Architectural Review and Historic Preservation Board Agenda Report

File: AR 16-20

RE: Chico Dermatology, 774 & 778 East Avenue, APN 007-110-006 and -007

ARB2

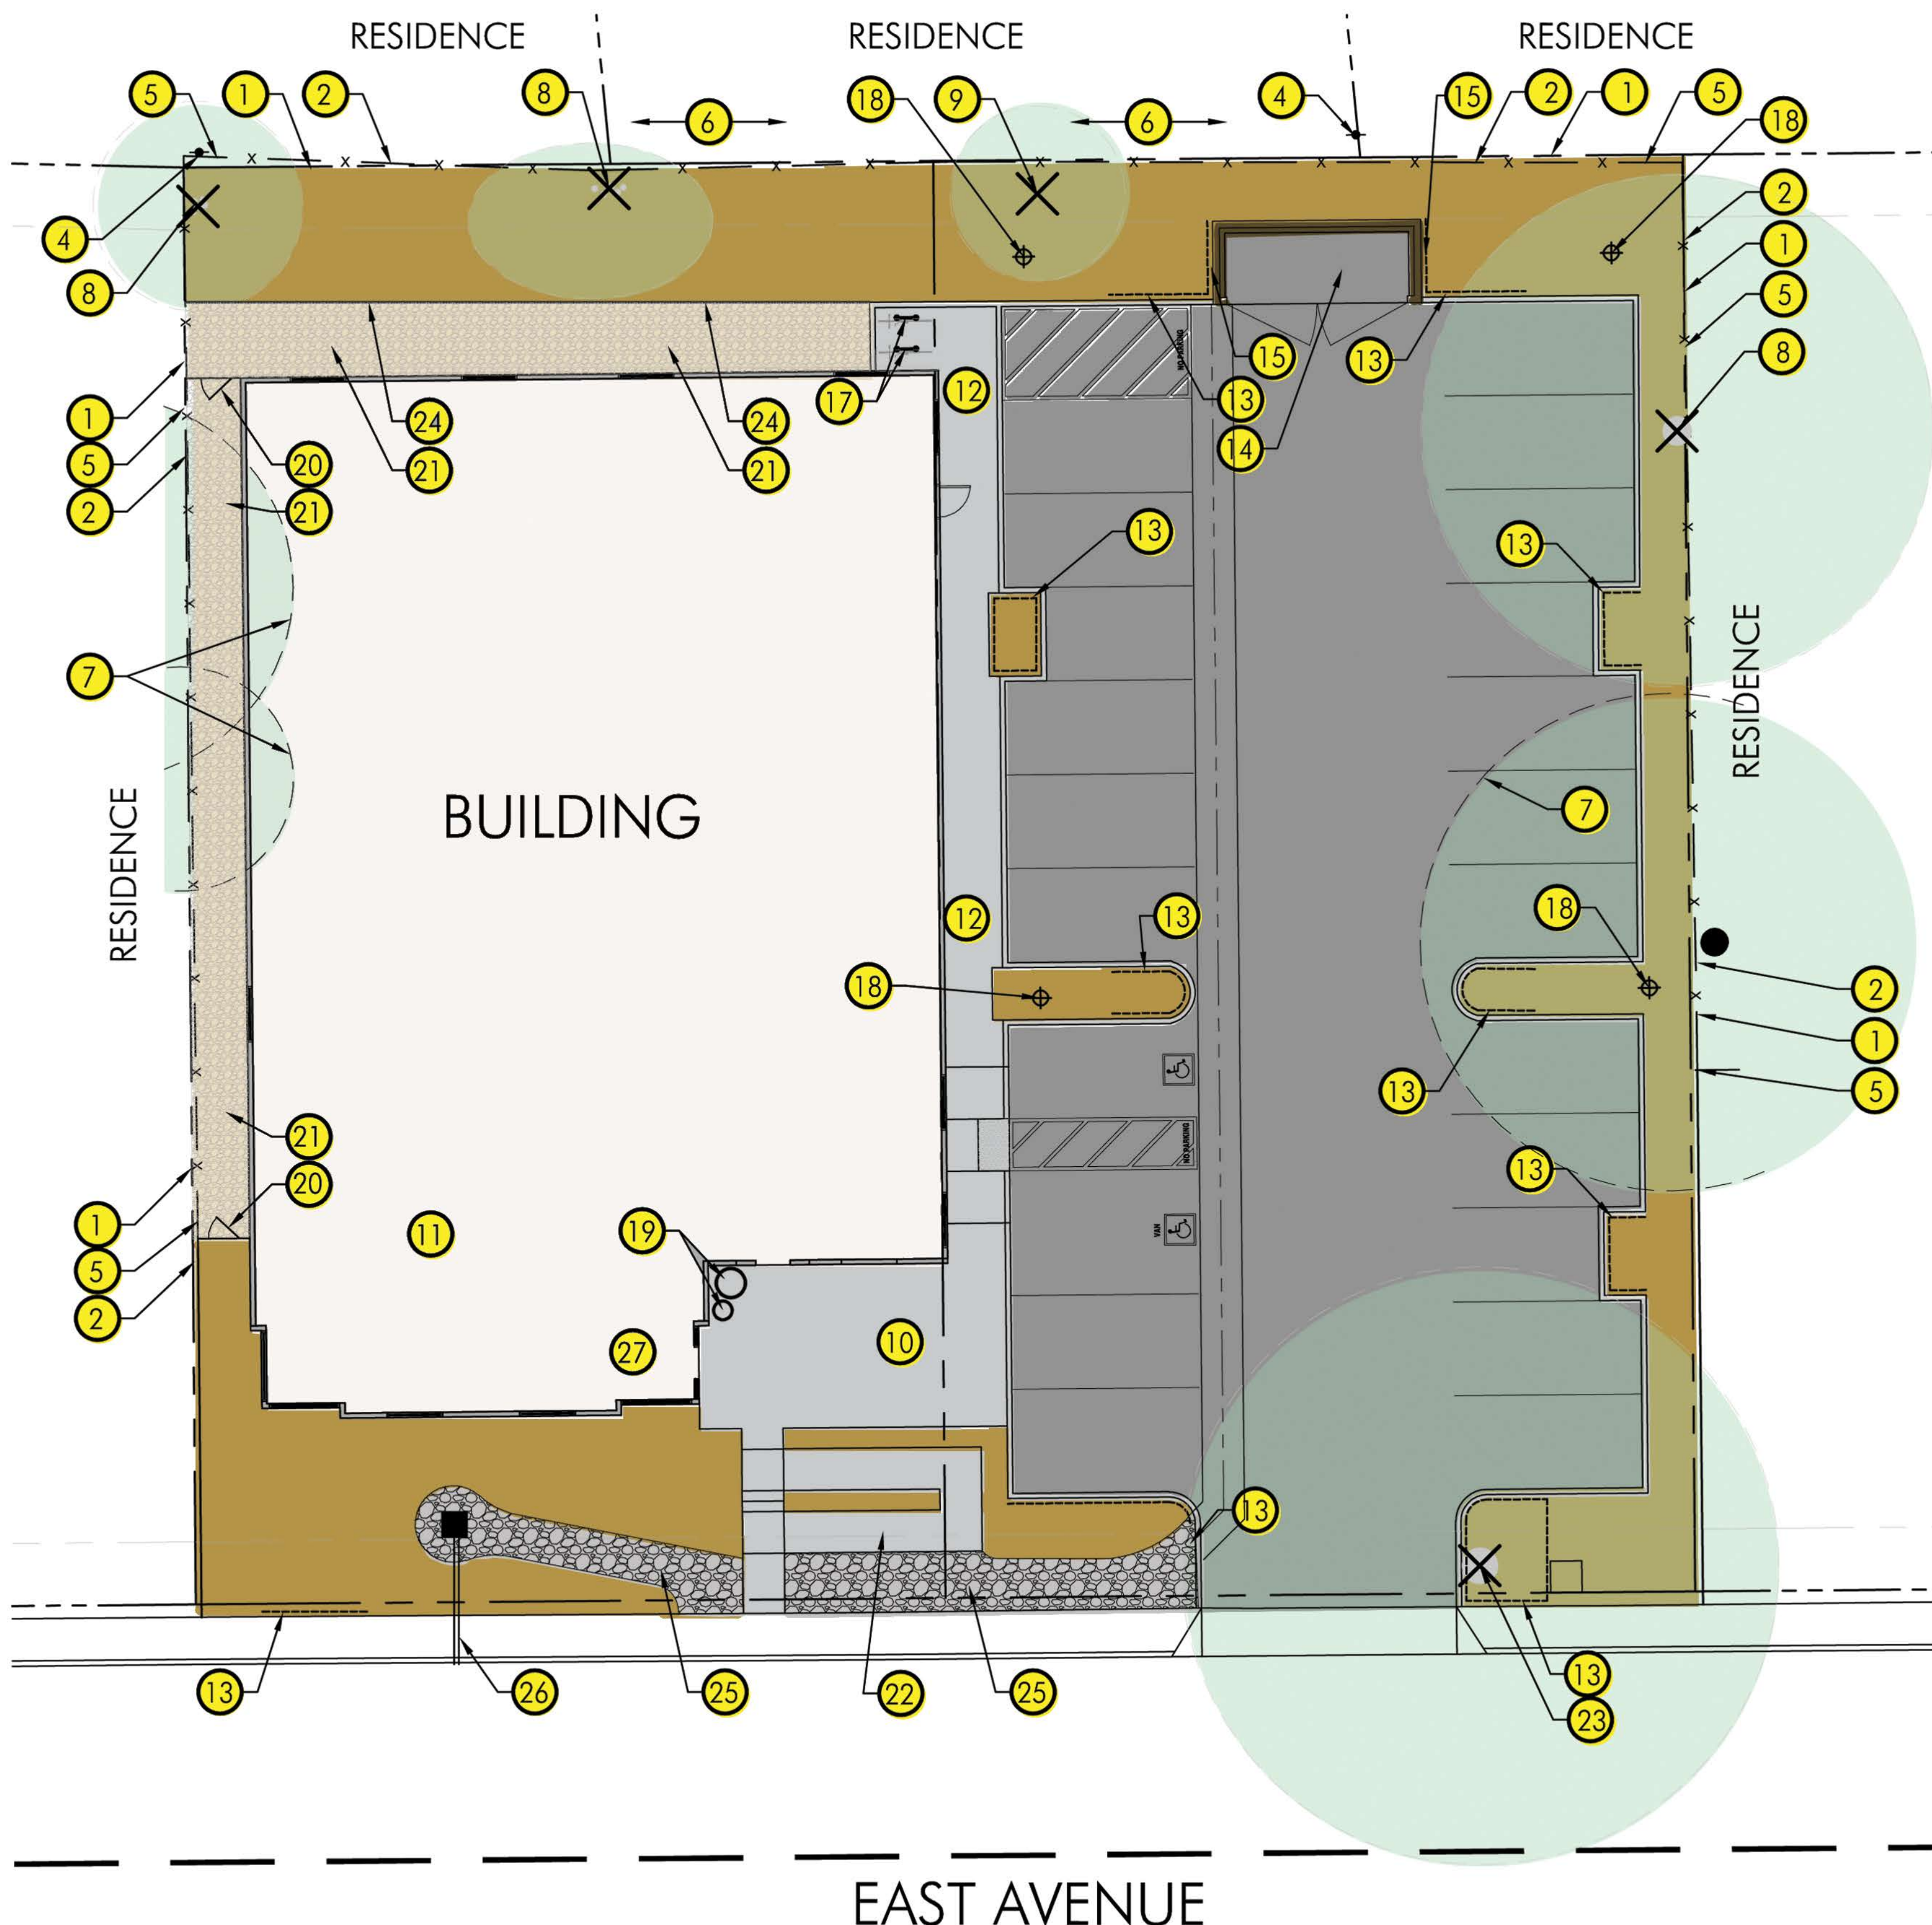
Vehicle access to the site would be provided from East Avenue leading to a 23-space parking area, located 10-feet back from the front property line and on the east side of the new office structure, in compliance with Chico Municipal Code (CMC) parking standards (see Site Plan, **Attachment C**). Two inverted U-style bicycle parking spaces would be provided at

the north end of the parking lot. Pedestrian access to the site would be available from East Avenue, connecting the public sidewalk to an onsite ADA-accessible path of travel. The project would remove and replace any deficient improvements along the East Avenue frontage.

A six-foot wooden fence exists along the side and rear property lines and would remain. For additional security, a six-foot locking wooden gate is proposed at the southwest corner of the building. Parking lot paving would result in the removal of one 42-inch diameter Ash tree located on the southeast corner of the project site, requiring seven mitigation trees to be planted (see Landscape Plan, **Attachment D**).

CHICO DERMATOLOGY (PAGE 1 OF 3)

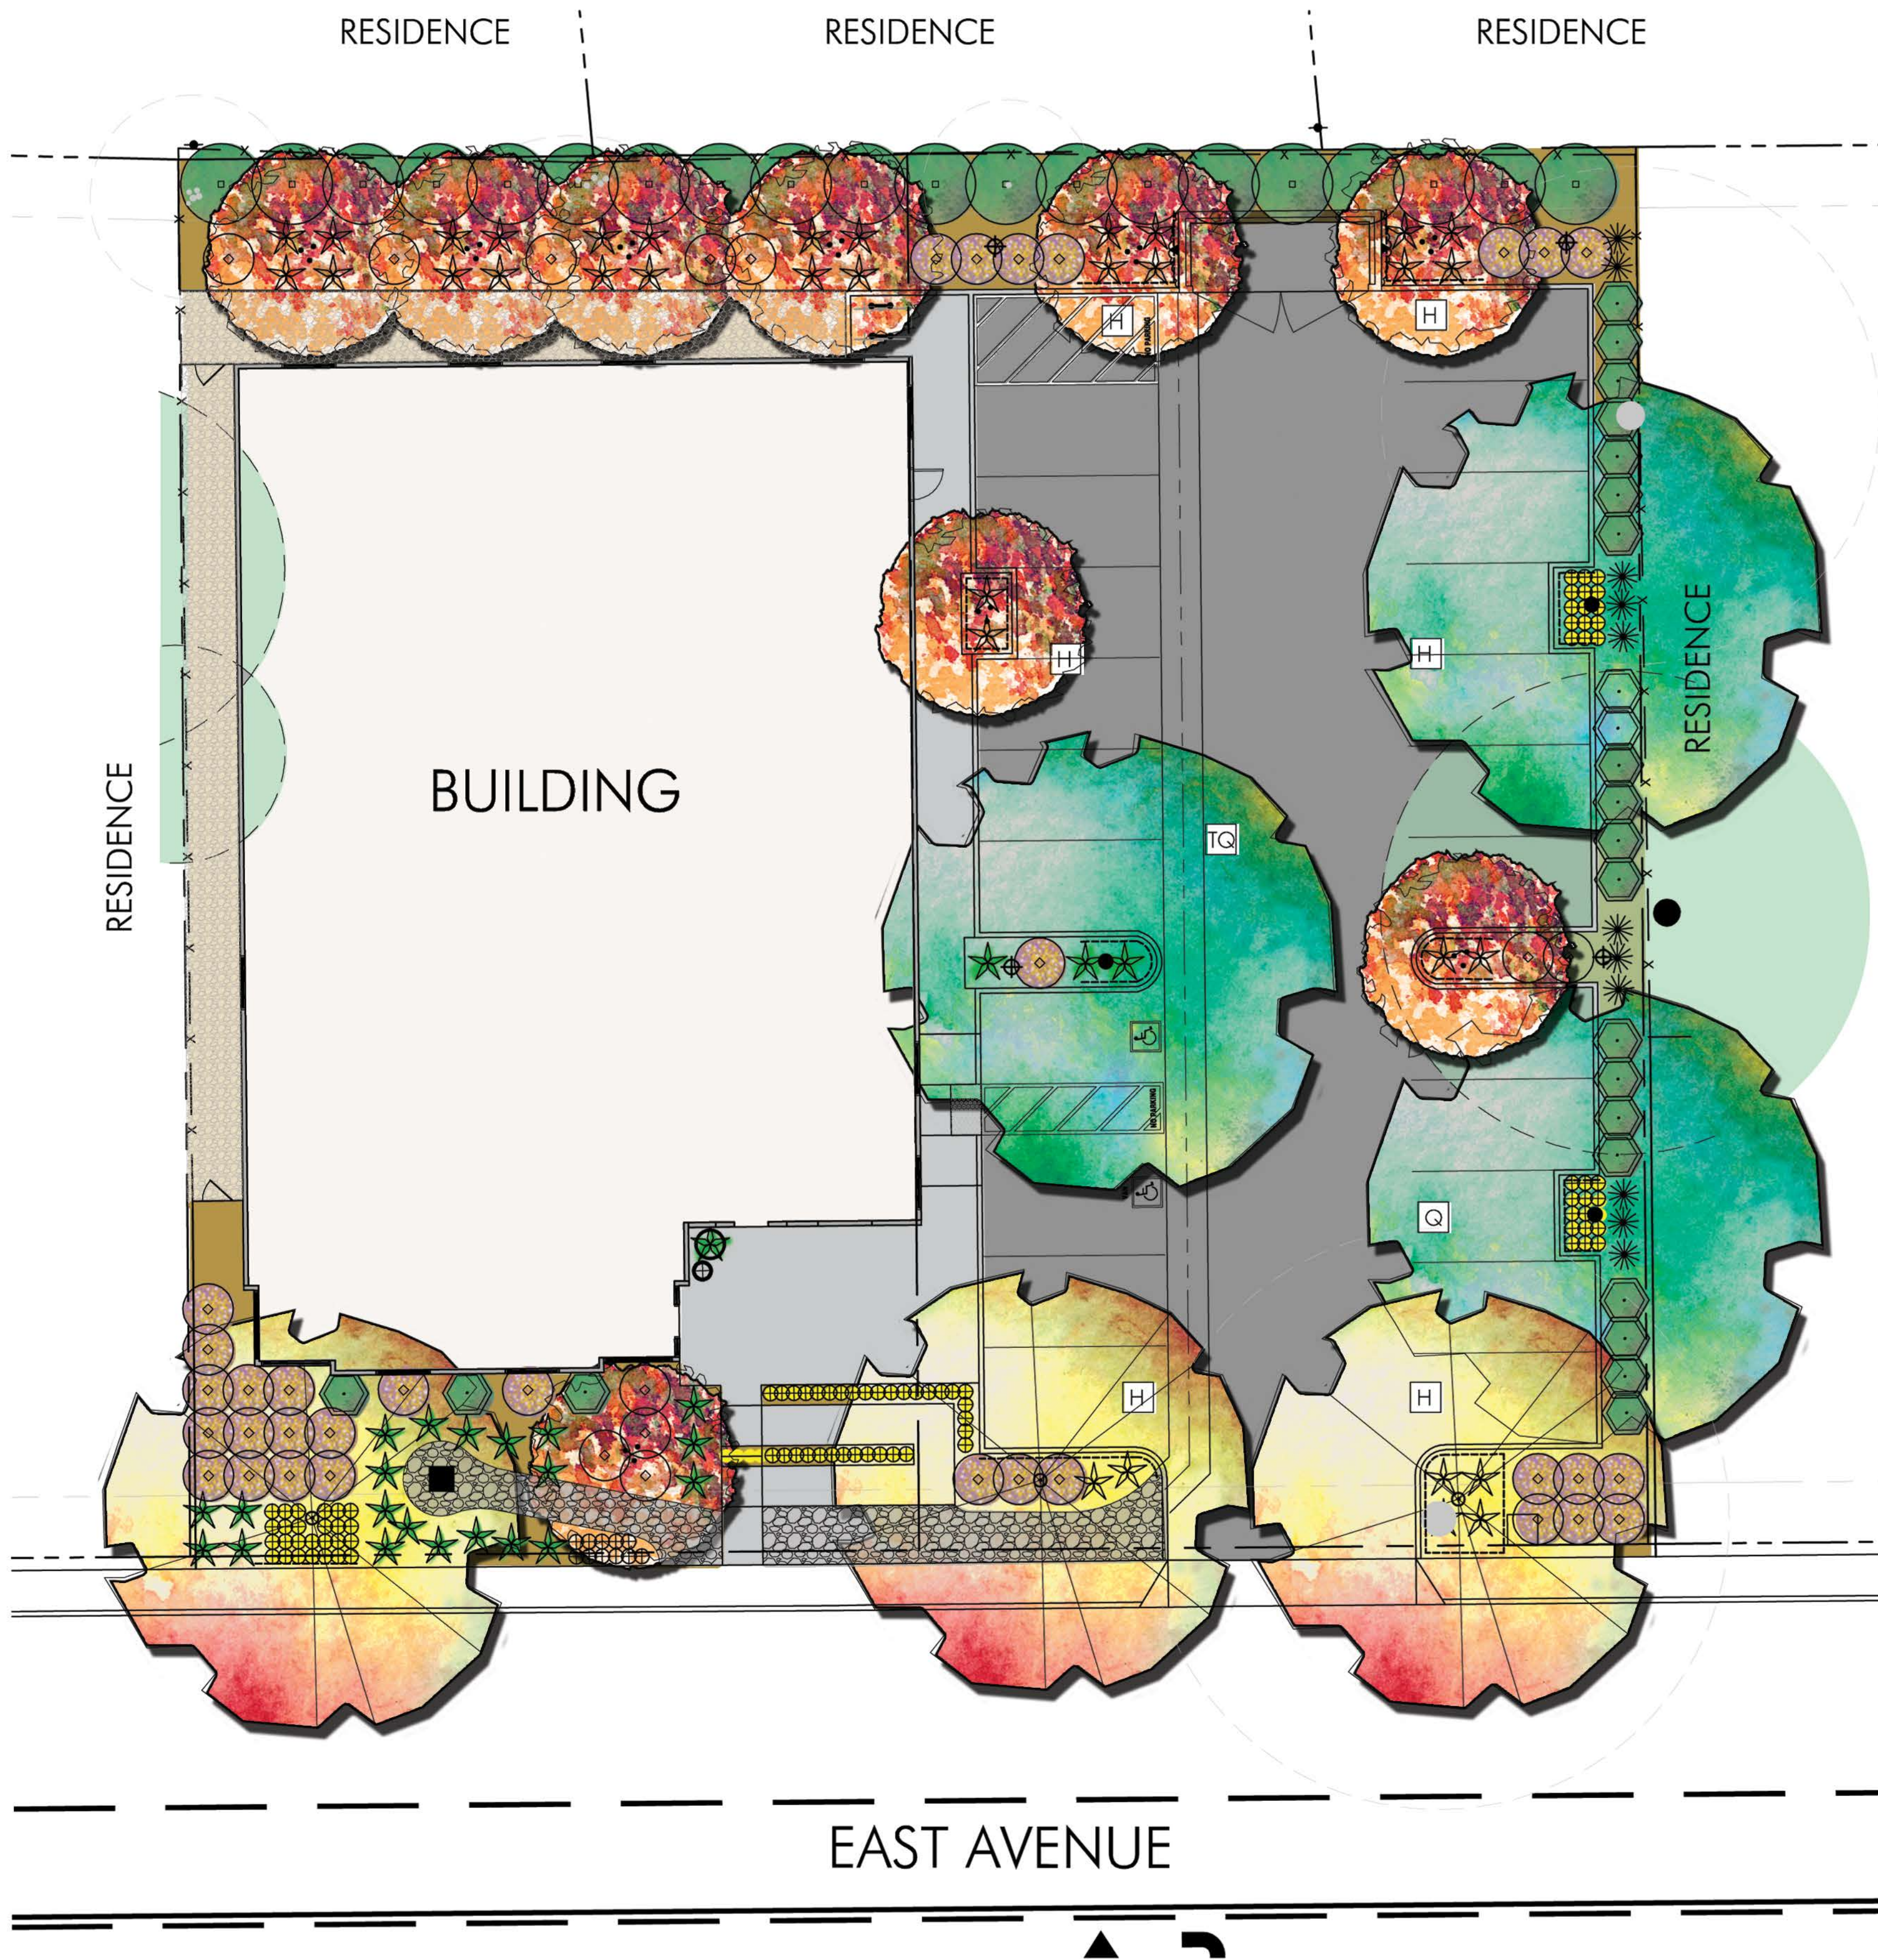
Parking lot shading would be provided by three eastern redbud trees located towards the rear of the property, two large Chinese pistache trees at the entrance of the parking lot, and three large scarlet oaks within the parking area, exceeding the 50-percent shading requirement. The trash enclosure, located at the rear of the parking area, would be walled and screened with creeping fig vines. Shrubs and groundcover are also proposed in the parking lot setback area and at various perimeter locations.

In addition to the parking lot shade trees, four eastern redbud trees, razzleberri fringe flower and manzanita shrubs would be planted behind the office building and along the northern property line. The southwest corner of the site (building entrance) would be landscaped with one Chinese pistache tree, one eastern redbud tree, a variety of shrubs, and a cobble rock swale. To further enhance the building's main entrance, a patio area and decorative, adobe-colored pre-cast concrete planting containers would also be incorporated into the design.

ARB5

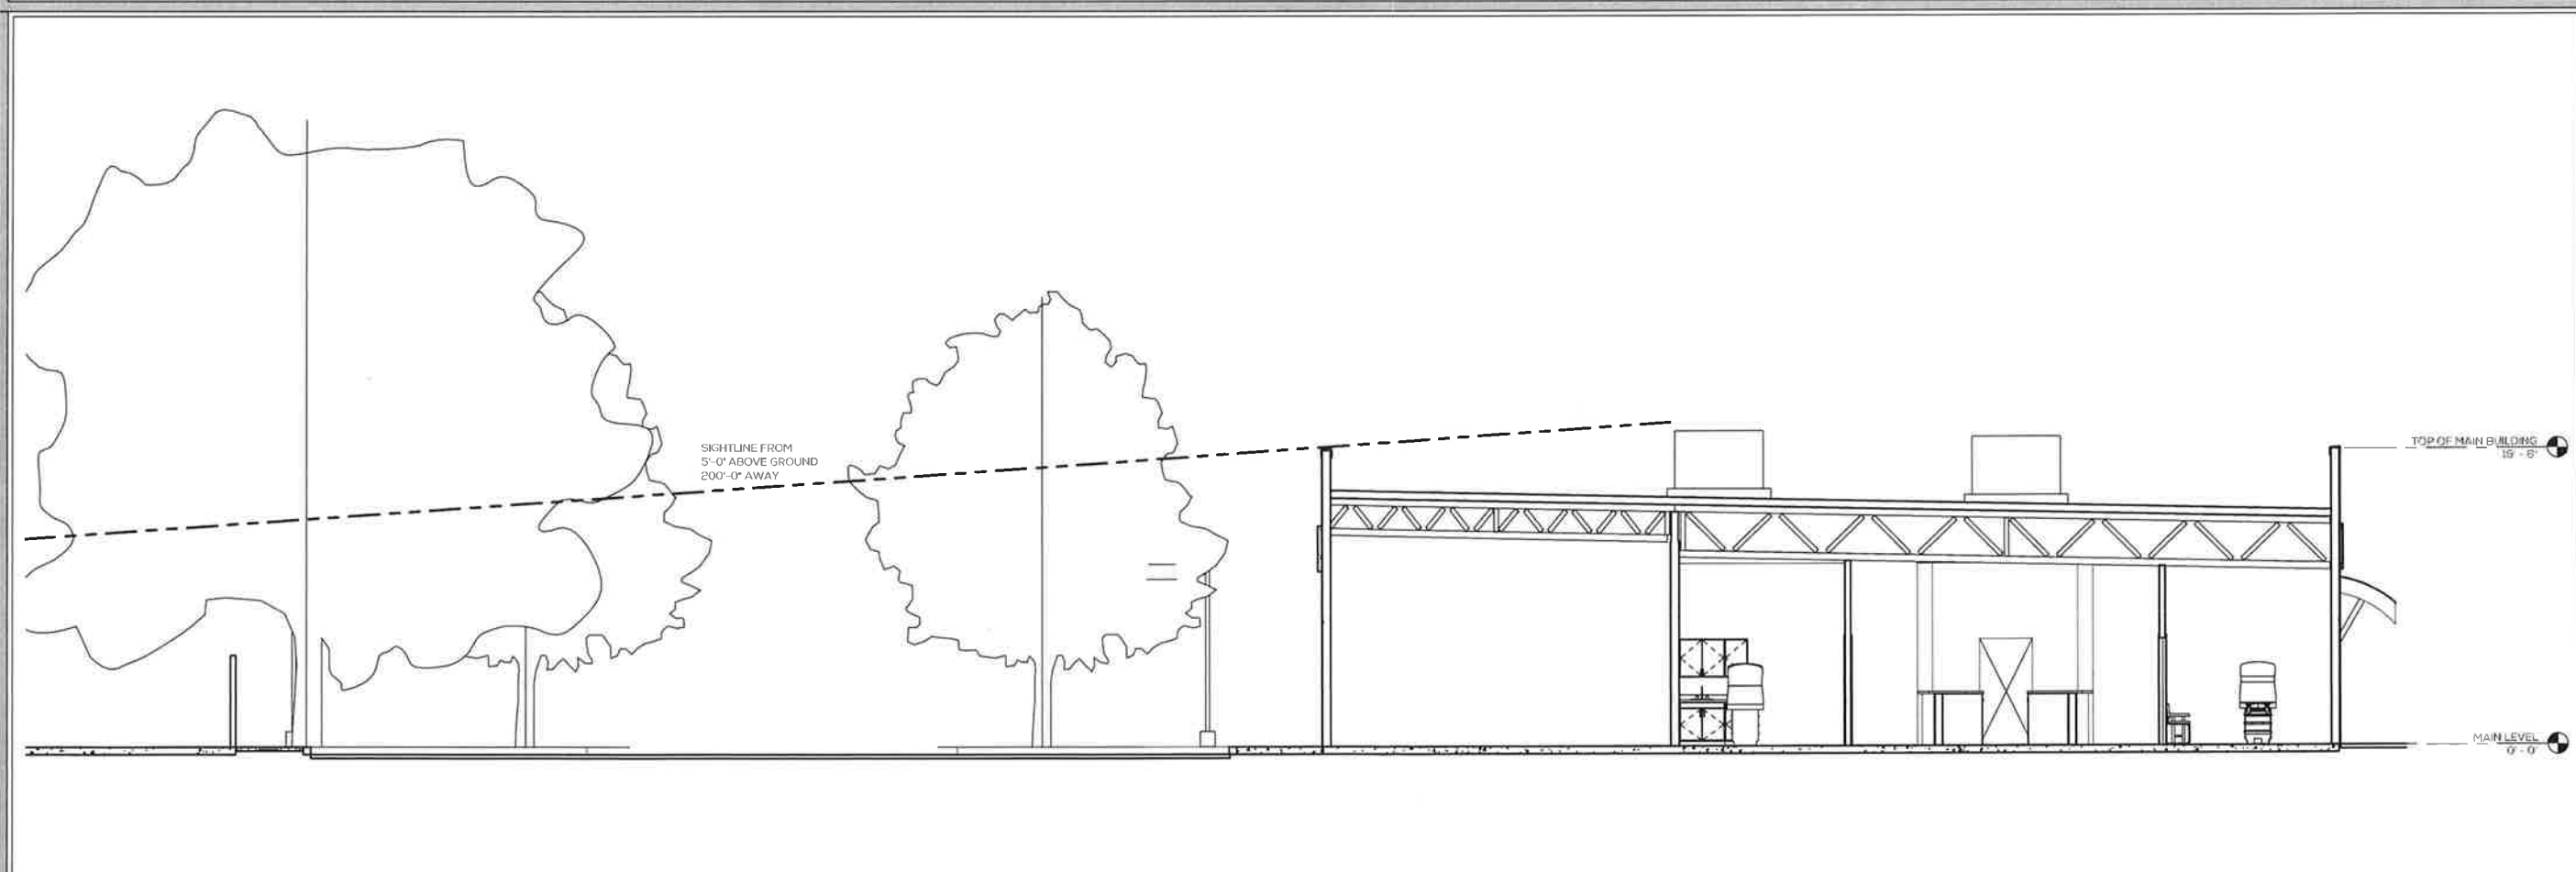
Exterior lighting proposed for the parking lot would consist of four standard "shoebox" style area lights, having a finished height of 12-feet, with glare cut-off shrouds. All HVAC units would be roof-mounted and shielded from view (see Mechanical Screening Sections, **Attachment G**).
